M E M O R A N D U M

RE: **113 Ely Place land division (Legistar 93071): Was Lot 2 confirmed as a legal lot before review of the Certificate of Approval?**

ADDENDUM A
113 ELY PLACE – PROPOSED LOT 2 (DEEP RESIDENTIAL LOT)
AREA CALCULATIONS AND RECORD OF THE METHOD

Figure 1. Reconstructed boundary and access strip overlaid on the CSM

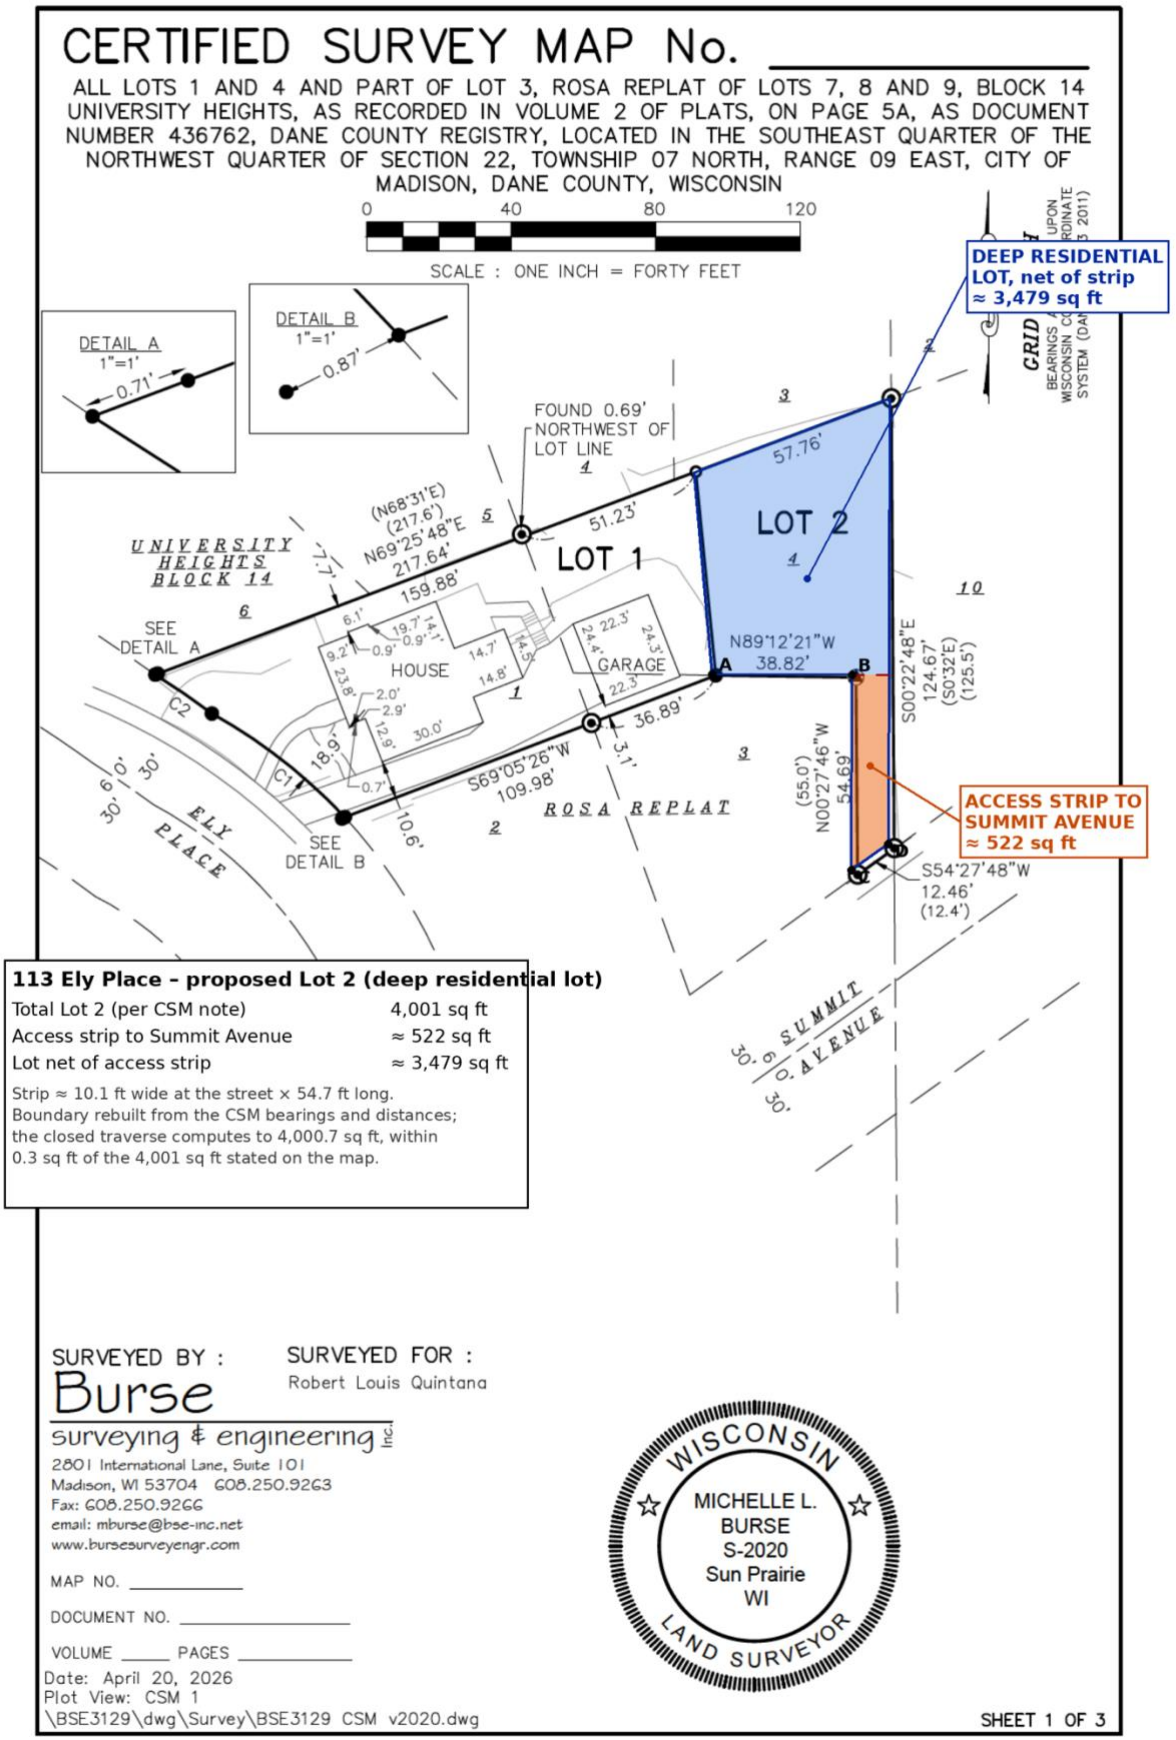
Strip. The access strip is the panhandle from Summit Avenue up to the point where the lot widens (corner B). Its top is the line from B across to the east line at B′ (54.59, −57.07). It is about 10.1 ft wide at the street and 54.69 ft long.

Net lot. 4,000.7 − 521.7 = 3,479.0 sq ft. The 4,001 sq ft on the CSM, therefore, includes the access strip; the area remaining after the strip is removed is about 3,479 sq ft.

Read together, the strip cannot count toward the lot's area requirement, and the lot must independently meet the minimum required lot area. The area available to satisfy that minimum is therefore about 3,479 sq ft, not 4,001 sq ft.

The City will make the determination on whether Lot 2 meets the standards for approval when we get a CSM application. As noted below, we do not have such an application so I cannot give you an exact date on when that will be made. For example, we do not have another application deadline for a CSM until July 20. ***If*** an application came in for that deadline it would be reviewed ahead of any PC/Council approvals in late Aug/early Sept, and it is during that review that we confirm the submitted CSM meets the standards for the lot.
